AMBIENT COMMUNITIES
179 Calle Magdalena Suite #201
Encinitas, CA 92024

March 28, 2022
PW 1912-01
Report No. 1912-01-B-6
City of San Diego Project No. 698277

Subject: **Geotechnical Addendum and Response to LDR-Geology Cycle 2 Review Comments, Multifamily Residential Development, 555 Hollister Street, San Diego, California**

SPT Name: B-5

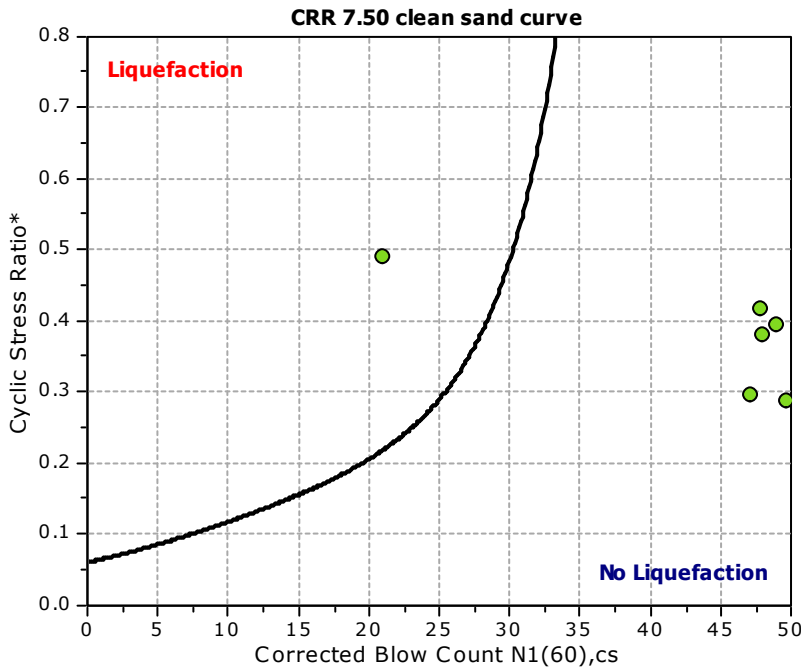
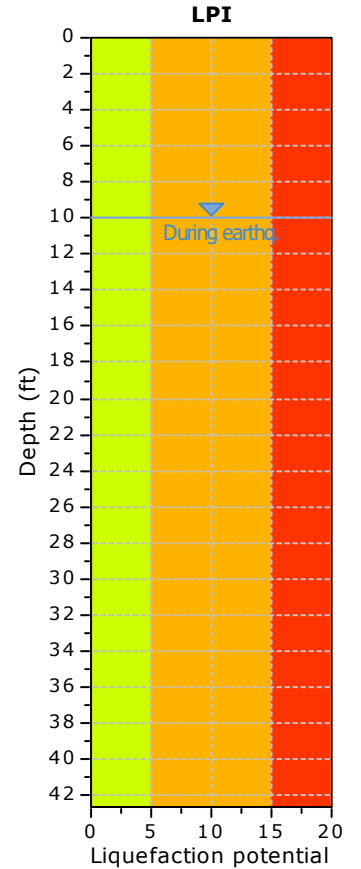
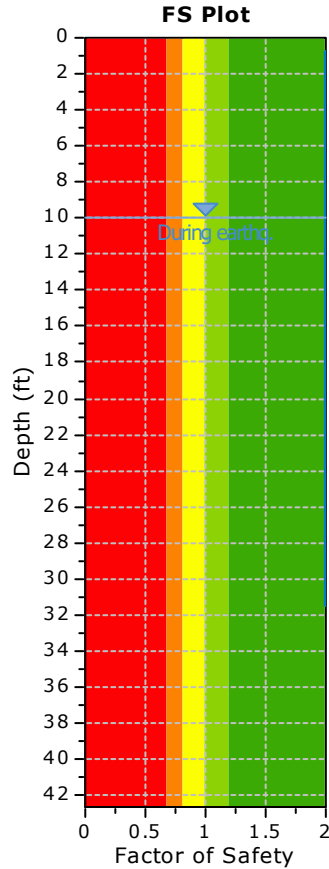
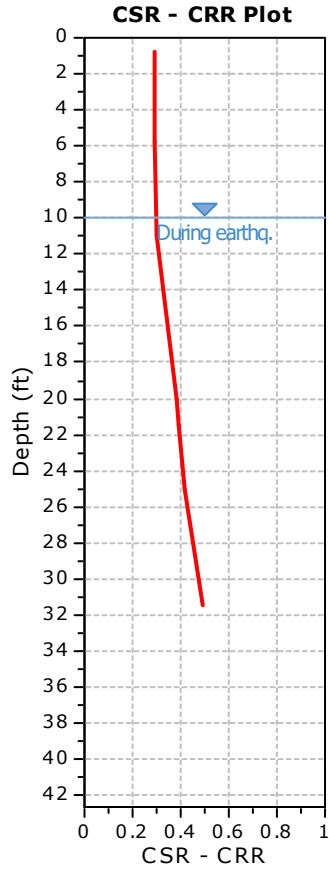
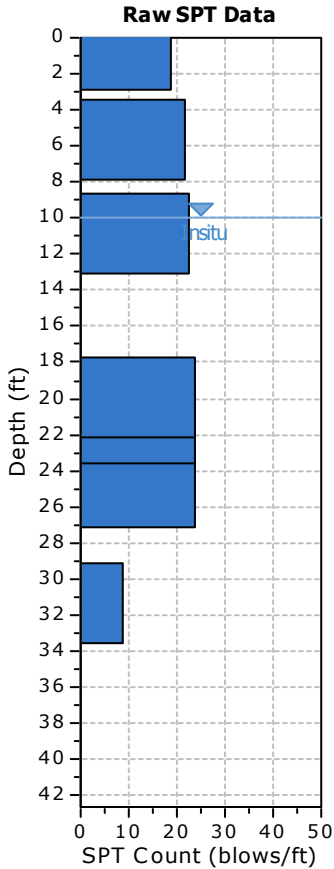
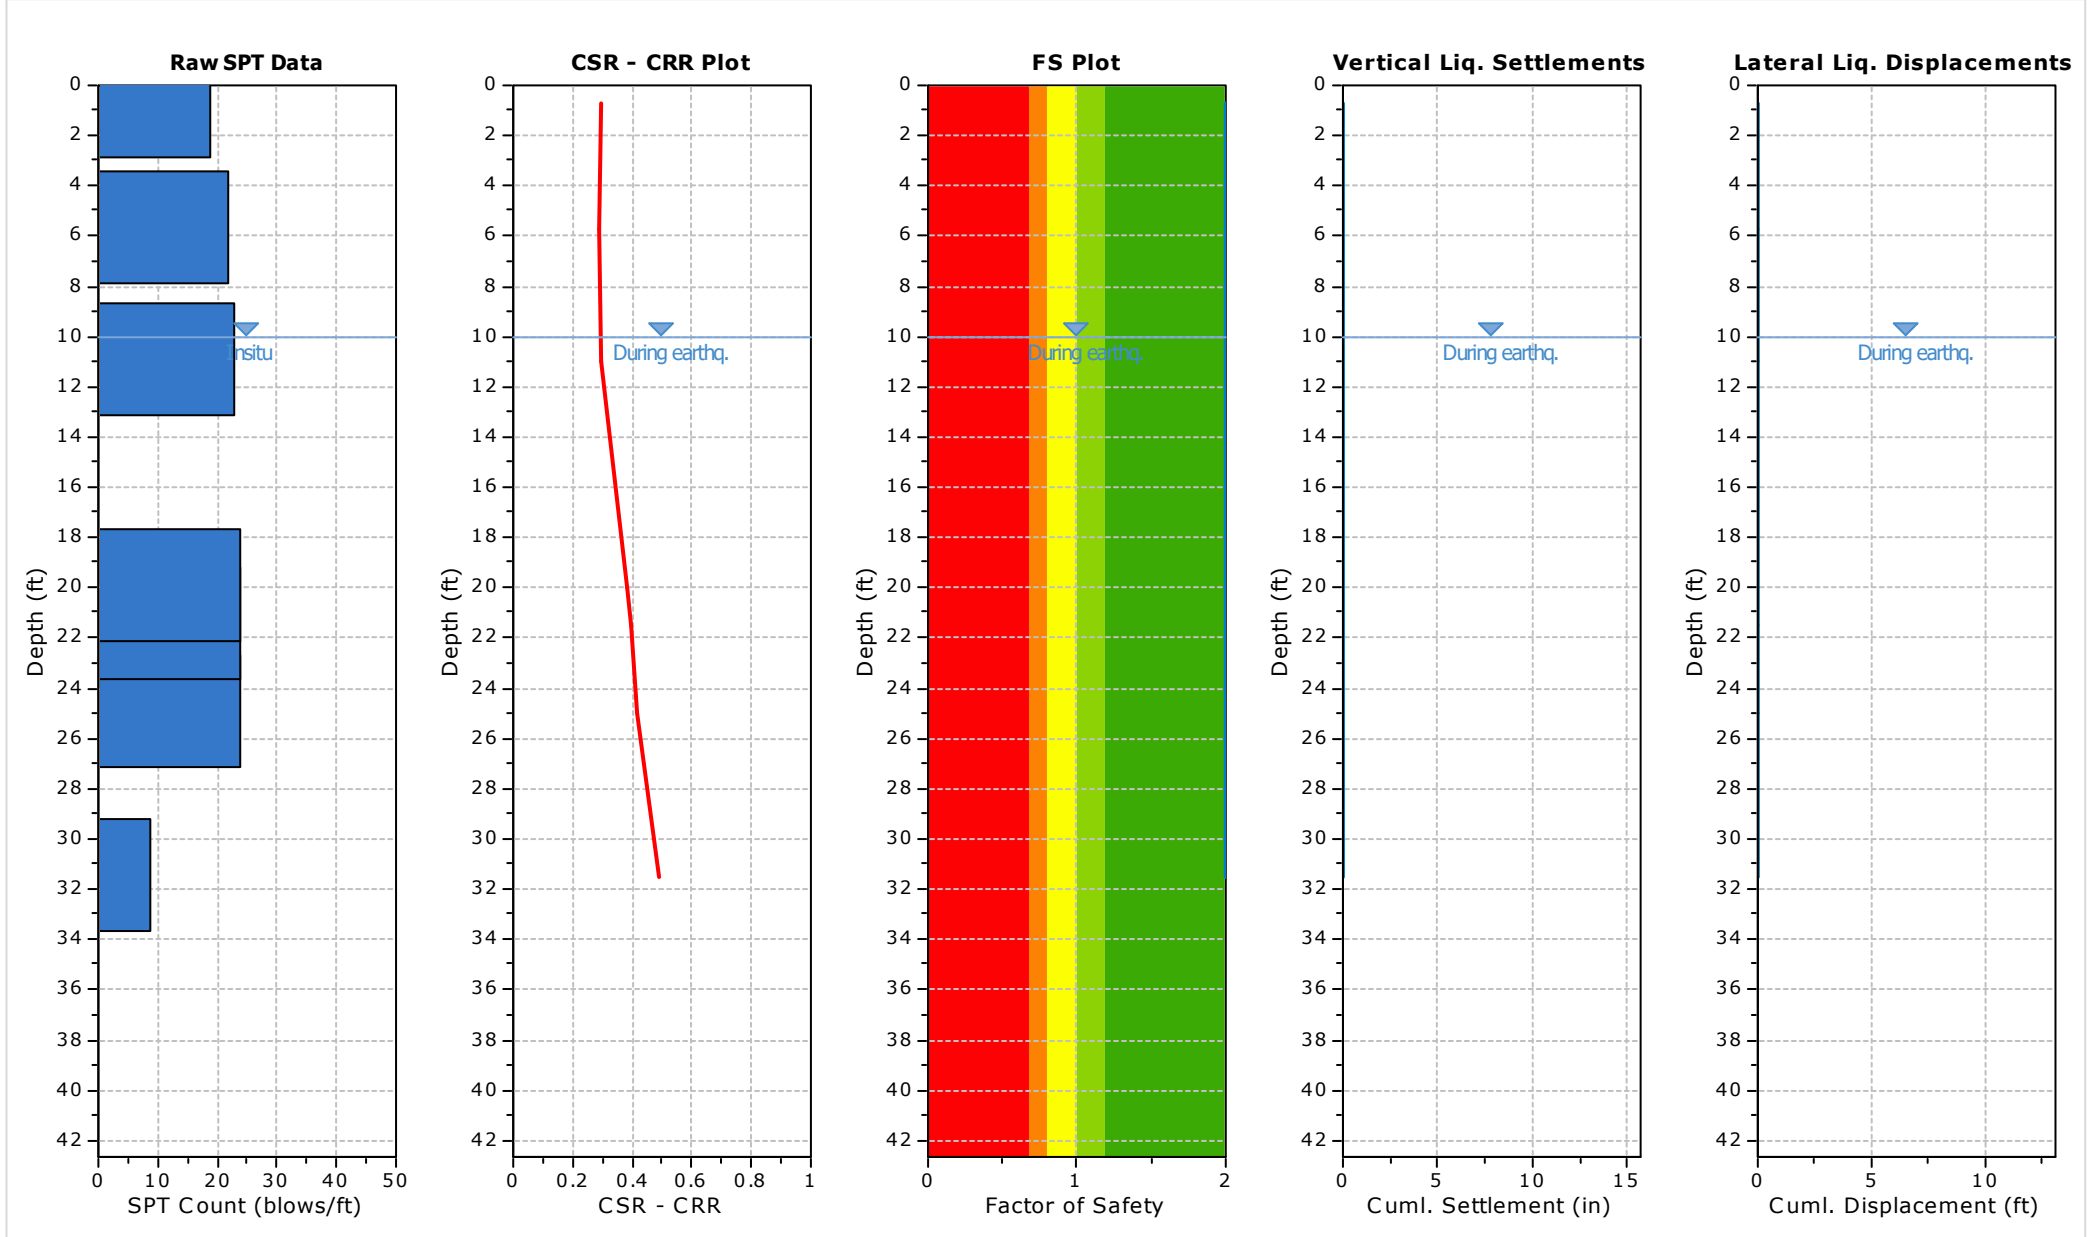
Item 5 -City of San Diego- *An area of the project site is located in geologic hazard category (GHC) 31 as shown on the City's Seismic Safety Study Geologic Hazard Maps. GHC 31 is characterized by a high potential for liquefaction. The geotechnical consultant must specifically address liquefaction potential of the entire site and potential consequences of soil liquefaction on the proposed development/ project.*

Item 6 -City of San Diego- *Address lateral spread or flow slide potential of the site. If impacts are indicated, provide recommended mitigation measures.*

Liquefaction and dry sand settlement analyses were performed using the computer program LiqSVs v.2.2 (Geoligismiki, 2019) and subsurface data from borings B-5 and B-7. The analyses considered an earthquake moment magnitude of 6.9, peak ground acceleration PGA_M of 0.62g, and groundwater level at El. 12.5 feet msl. Our analyses indicate that no liquefaction settlement will occur in boring B-5 and B-7. Dry sand settlement of approximately 0.5 inches during a seismic event was estimated at about 5 foot depth within boring B-5 as shown in Appendix B.

AGS Response – The liquefaction analyses presented in Appendix B indicate that the potential displacement due to lateral spread for borings B-5 and B-7 is zero. Since the recommended removal and recompaction measures will mitigate liquefaction onsite, it is anticipated that any potential lateral spread will also be mitigated.

PLATE 1

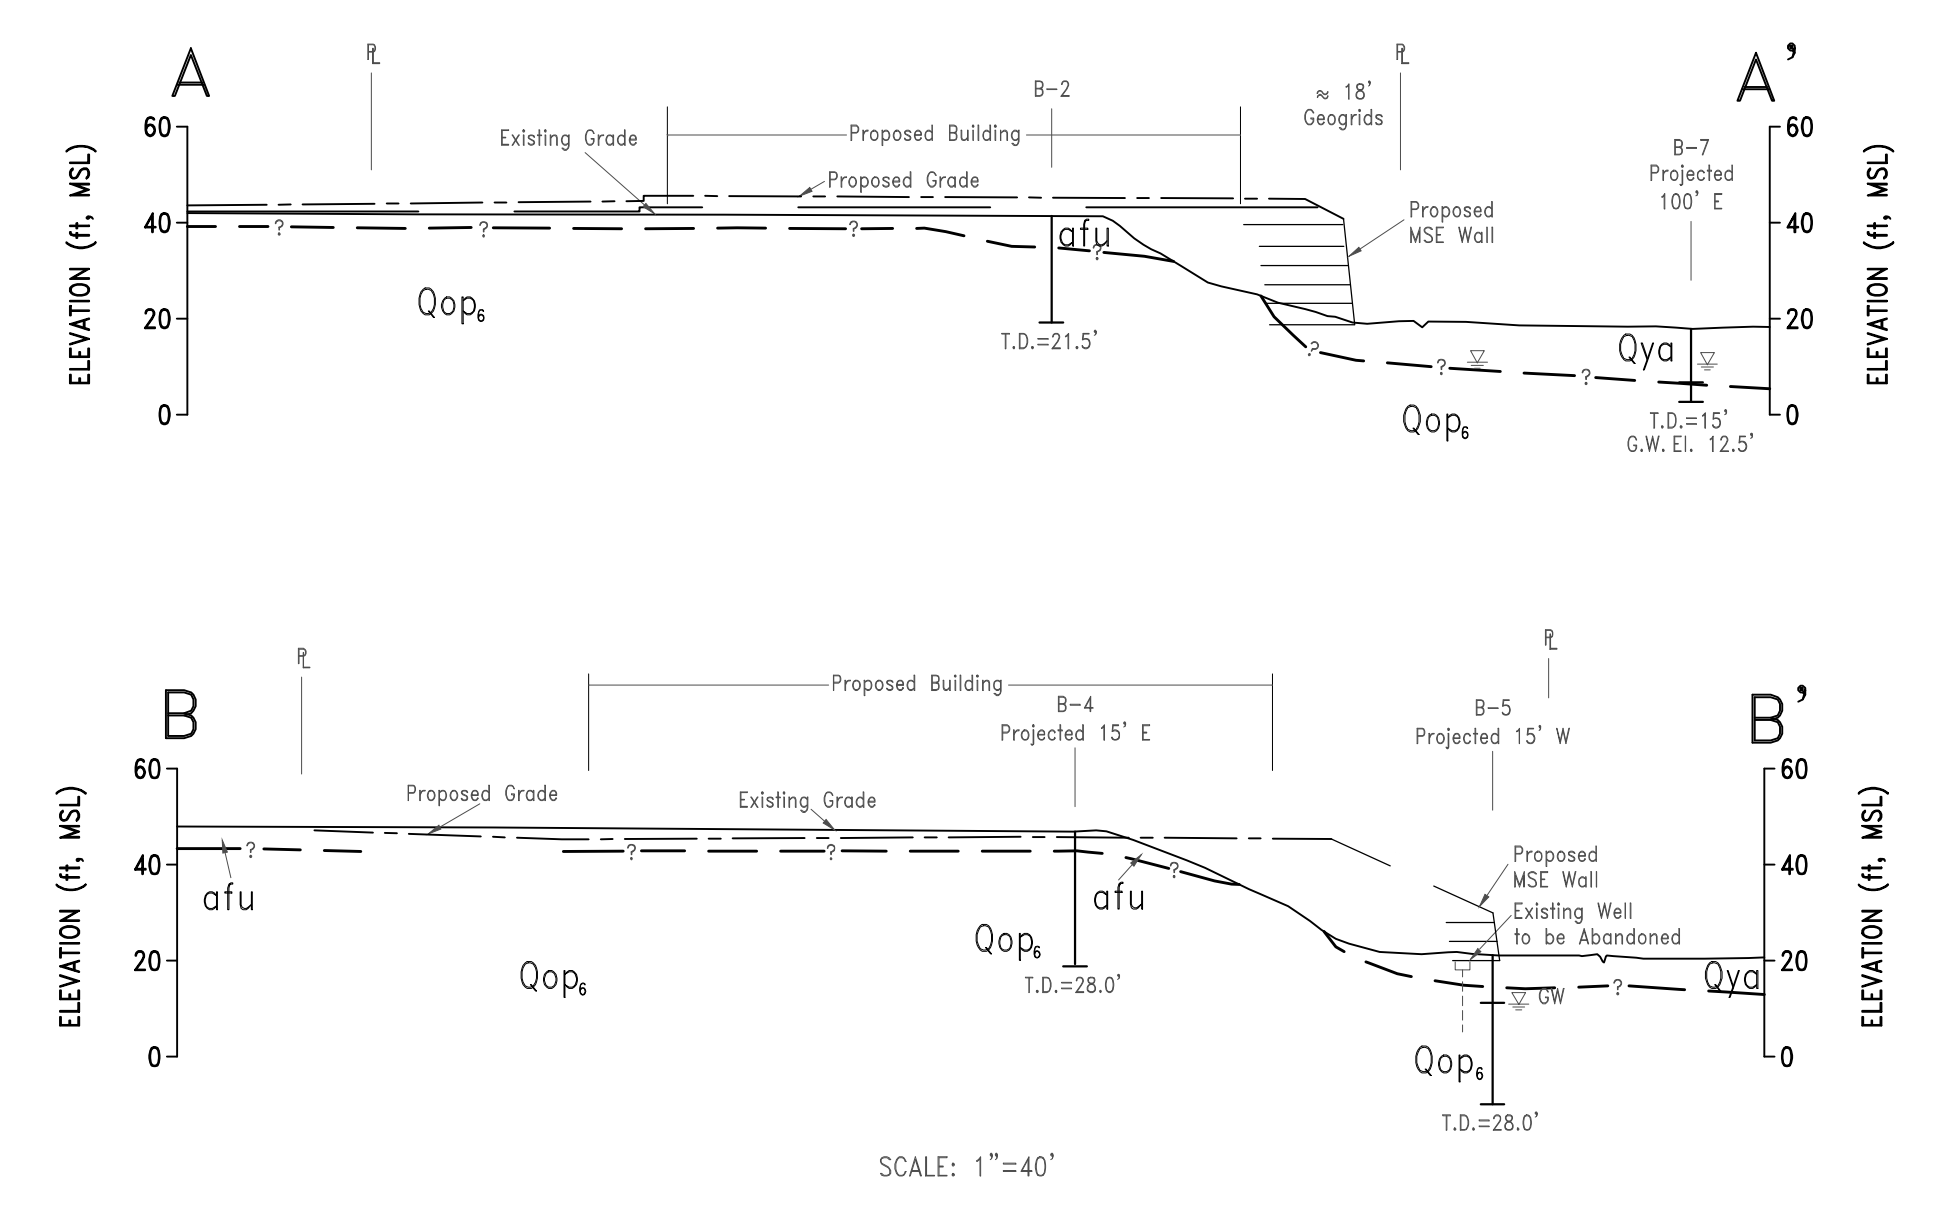
Item 2 -City of San Diego- *Submit an addendum geotechnical report or update letter that specifically addresses the proposed development for the purposes of environmental review and the following:*

Item 3 -City of San Diego- *The geotechnical consultant must indicate if the site is suitable for the proposed development as designed or provide recommendations to mitigate the geologic hazards to an acceptable level.*

AGS Response - AGS has updated the attached Plate 1, Geologic Map and Exploration Location Plan showing the exploratory locations, site geology, and geologic cross sections using the current Grading and Drainage plan (Sheet C005) by Pasco Laret Suiter & Associates (PLSA) dated November 10, 2021 as a base map. Based on our review of the current grading plan, the site is suitable for the proposed development as designed. The referenced geotechnical report by AGS (2021a) provided recommendations that should be incorporated into the design and construction of the project and will mitigate the site geologic hazards to an acceptable level.
